# Access Compliance Report

## Public Rights-of-Way

### (Curb Ramps)

Intersection ID: 16634	Main Street: OLD_PINEVILLE_RD	Cross Street: YANCEY_RD	Location: NW
ADA ID: 76CDC0434D84	Ramp Type: PerpDiag	Initial Pass/Fail: Fail	Overall Compliance: No
		Severity Score: 8.75

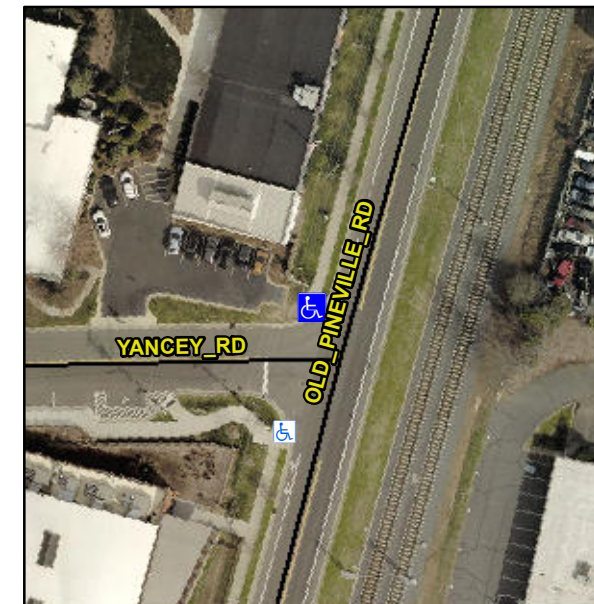
**Not Found, R304.5.1**

Compliance	Description	Data	Compliance	Description	Data
N/A	Ramp Length (in)	47.0	Yes	Ramp Slope (%)	8.0
No	Ramp Width (in)	46.0	Yes	Ramp XSlope (%)	0.9
N/A	Flare Type LT	N/A	N/A	Flare Type RT	N/A
N/A	Flare Slope LT (%)	N/A	N/A	Flare Slope RT (%)	N/A
N/A	Flare Traversable LT?	N/A	N/A	Flare Traversable RT?	N/A
N/A	Landing Length (in)	N/A	N/A	DWS Provided?	N/A
N/A	Landing Width (in)	N/A	N/A	DWS Contrast?	N/A
N/A	Landing Slope (%)	N/A	N/A	DWS Length (in)	N/A
N/A	Landing X Slope (%)	N/A	N/A	DWS Full Width?	N/A
N/A	Landing Curb? (Y/N)	N/A	N/A	DWS Offset (in)	N/A
N/A	Shared Landing?	N/A			
N/A	Gutter Ponding?	N/A	N/A	Gutter Slope (%)	N/A
N/A	Gutter Lip Ht (in)	N/A	N/A	Gutter X Slope (%)	N/A
N/A	Painted X Walk1?	No	N/A	Painted X Walk2?	No
	X Walk 1 Direction	To SW		X Walk 2 Direction	To E
N/A	X Walk 1 Width (in)	N/A	N/A	X Walk 2 Width (in)	N/A
	X Walk 1 Slope (%)	1.5		X Walk 2 Slope (%)	4.0
	X Walk 1 X Slope (%)	1.5		X Walk 2 X Slope (%)	0.6

**Remove & Replace Curb Ramp With Two New Directional Ramps or Equivalent.**
